AGENDA

Village of Arlington Heights

July 16, 2018

- A. Hickory/Kensington - 4 N. Hickory Ave. - PC#18-005
Planned Unit Development, Preliminary Plat of Subdivision, Variations
- B. Christian Liberty Subdivision - 502 W. Euclid Ave. - PC#18-011
Preliminary & Final Plat of Subdivision, Variations

05.31.18 RND 1 REVIEW COMMENTS
03.05.18 PLAN COMMISSION REVIEW
REVISIONS
DRAWN BY: MAM
APPROVED BY: G.C.N.
SCALE: AS NOTED
DESCRIPTION: LANDSCAPE PLAN

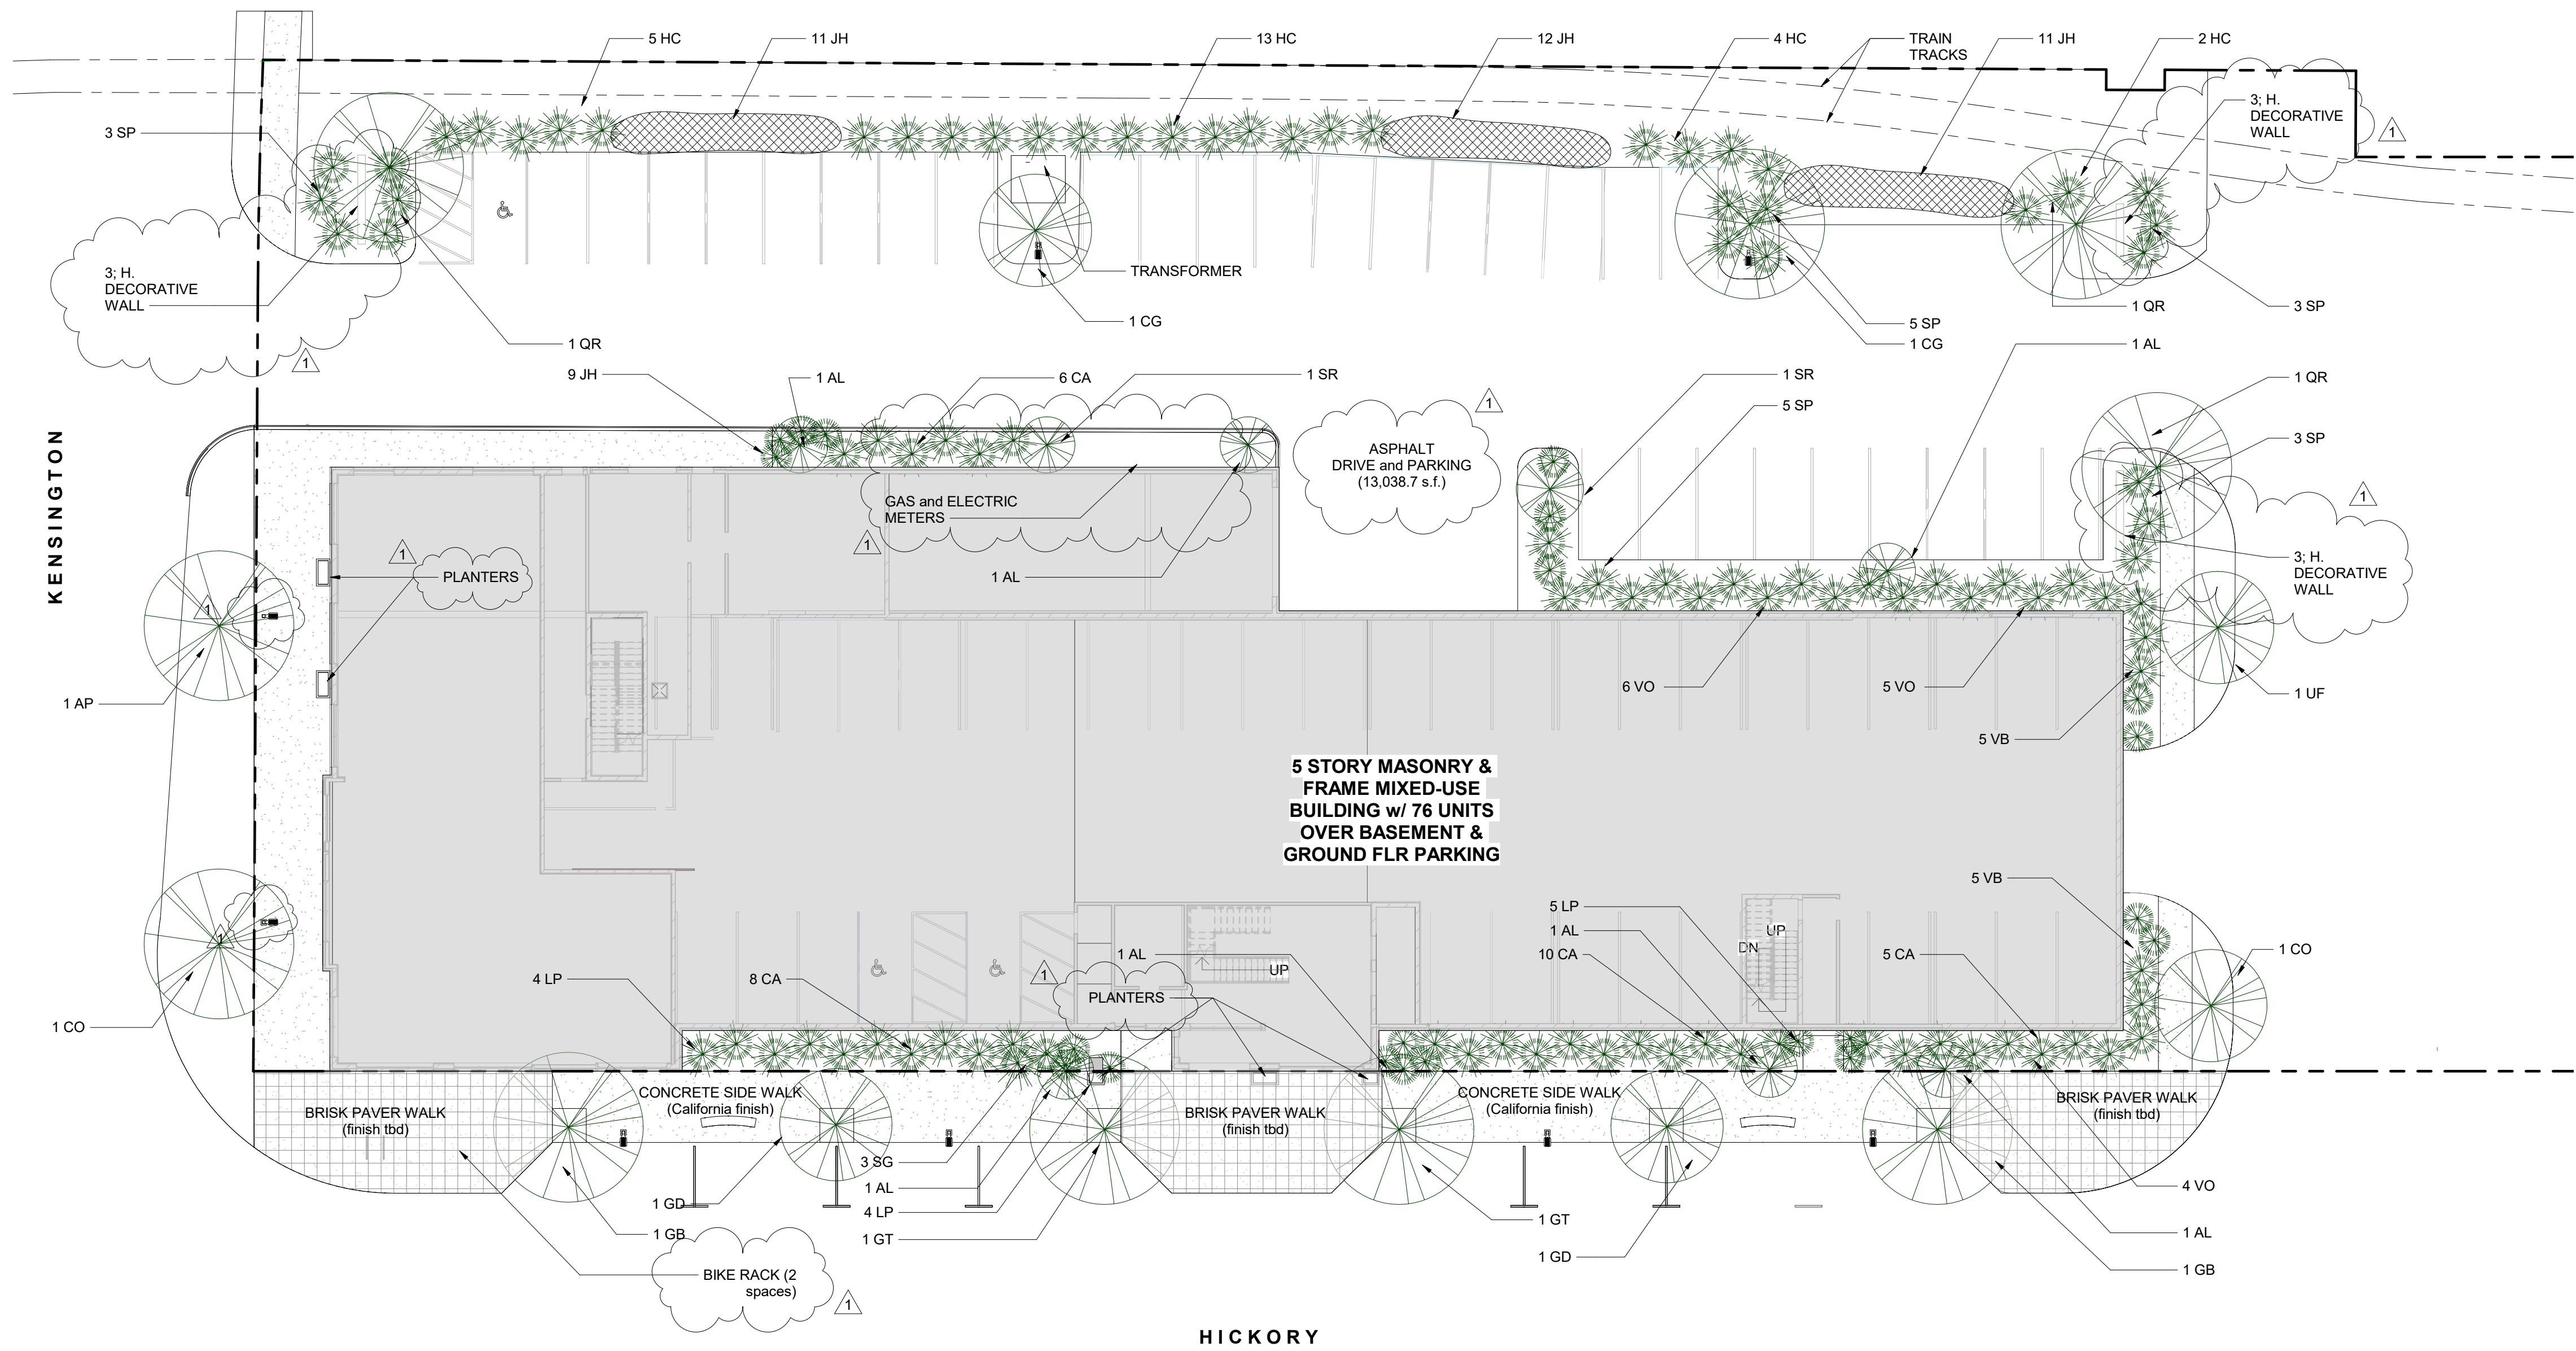
The landscaping plan has been adjusted and revised to accommodate the above. See sheet PC1-1.2

Planters have been added to landscape plan. See sheet PC1-1.2

SHEET NO.
PC6-1.0

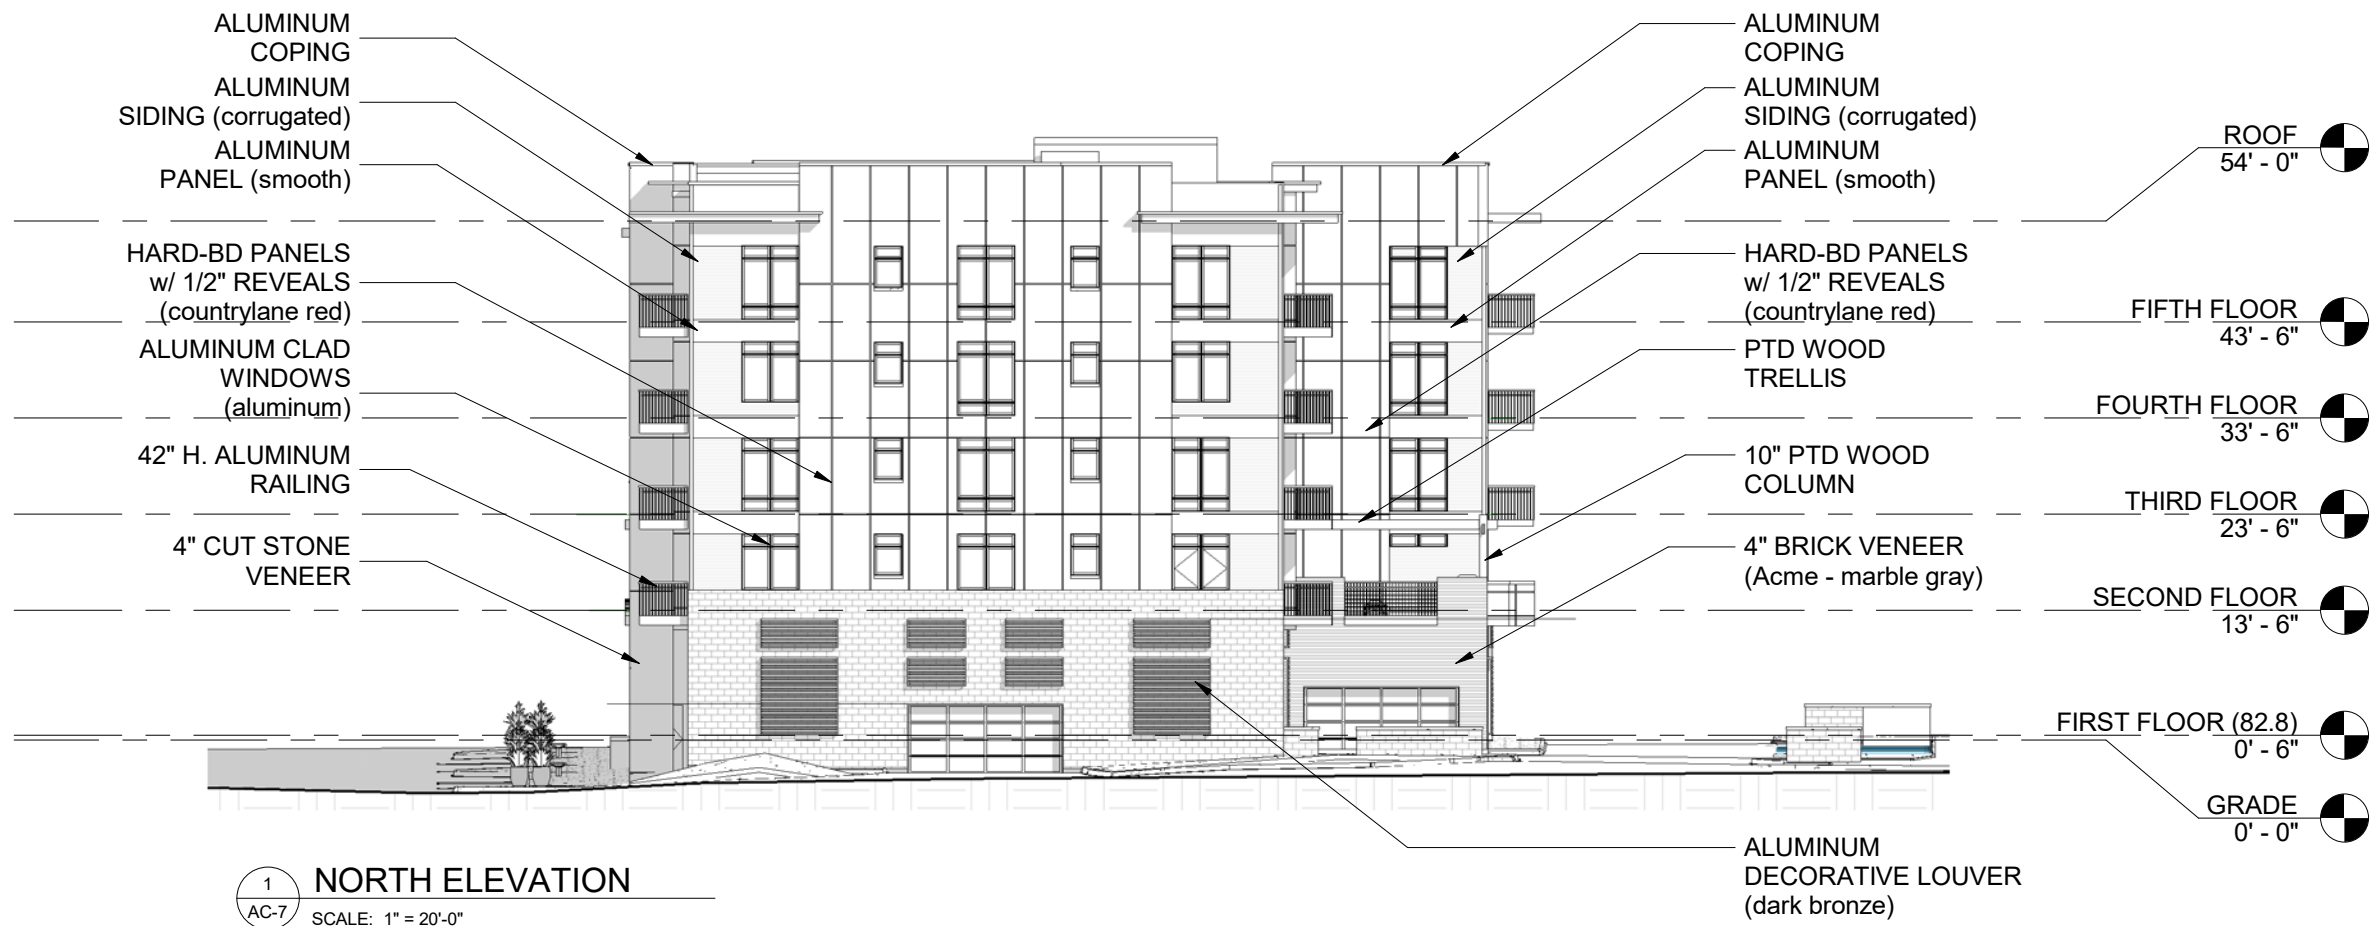
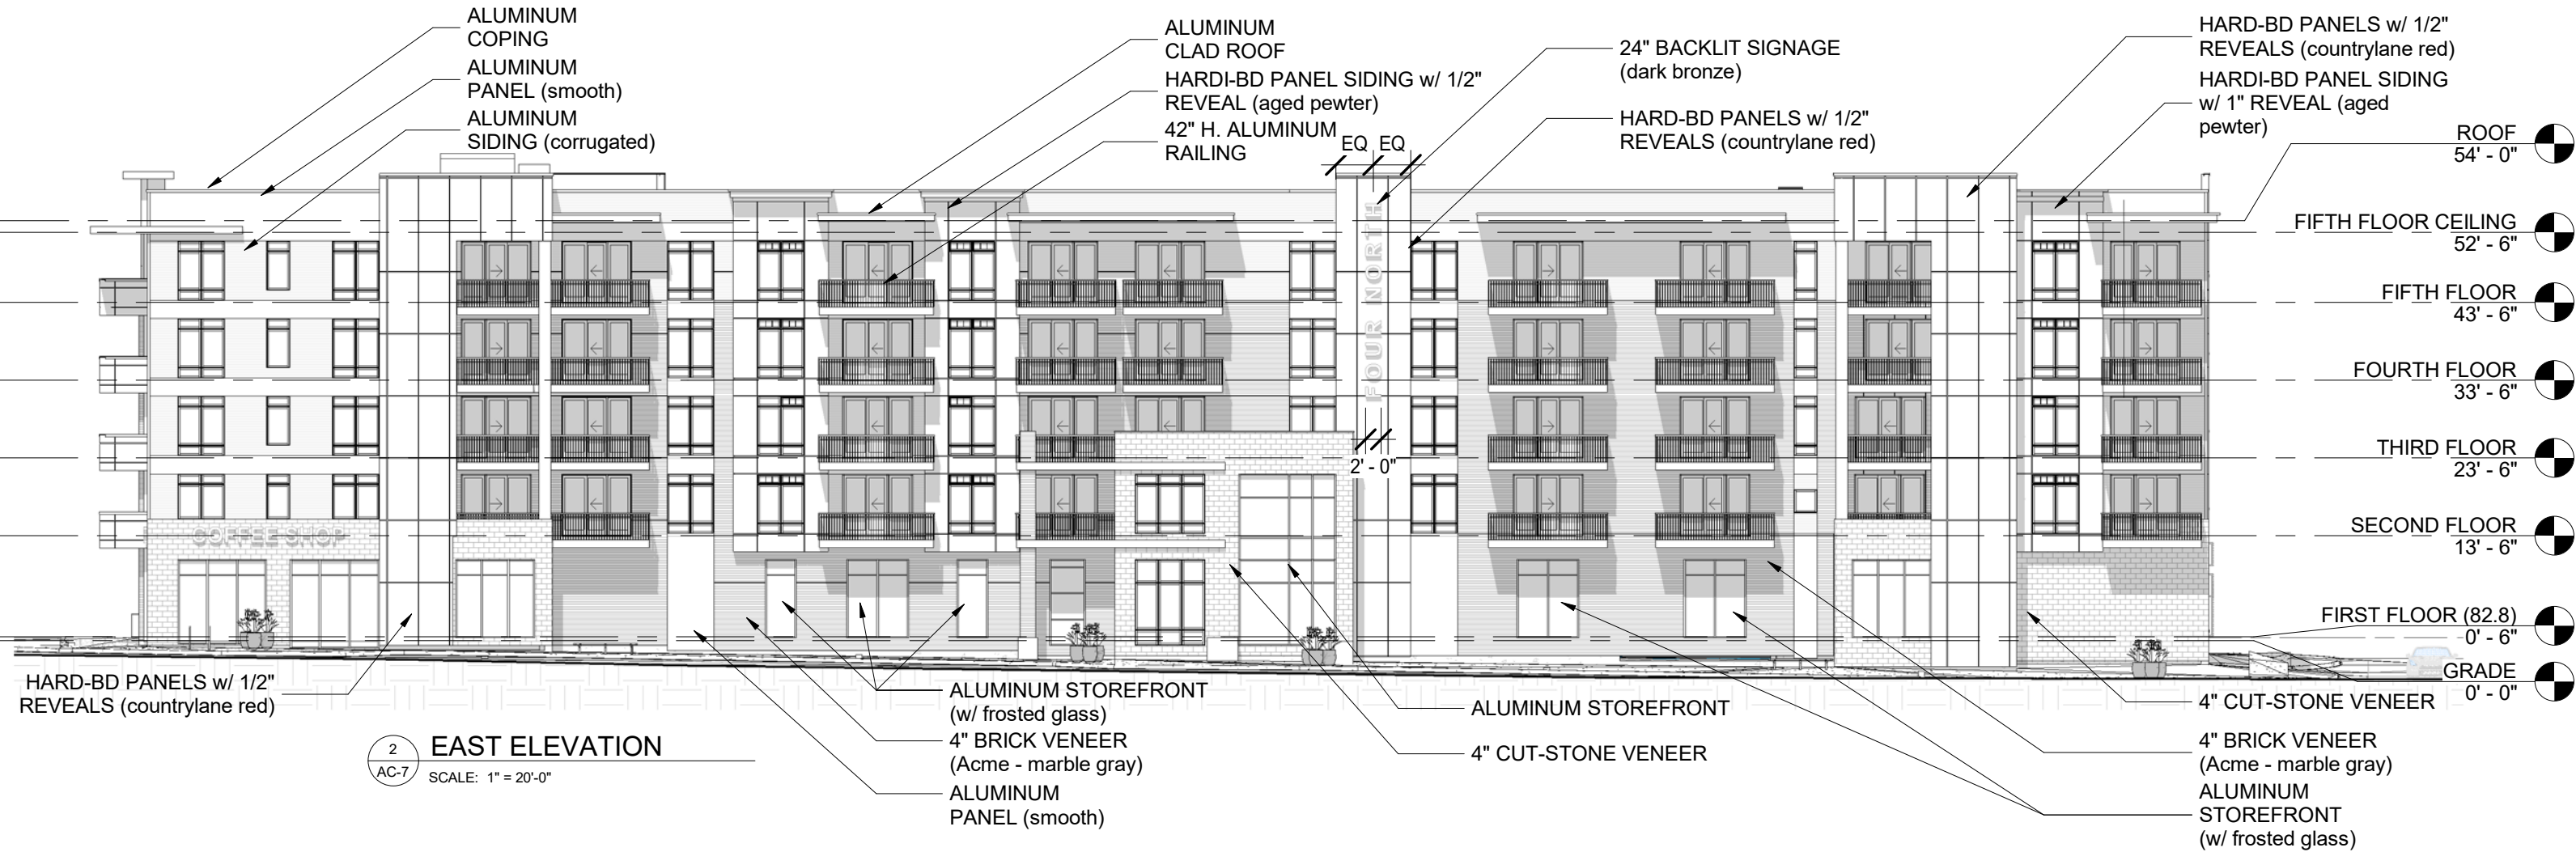
The 54' height is measured to the top of the roof. The section on sheet PC6-1.0 has been revised accordingly
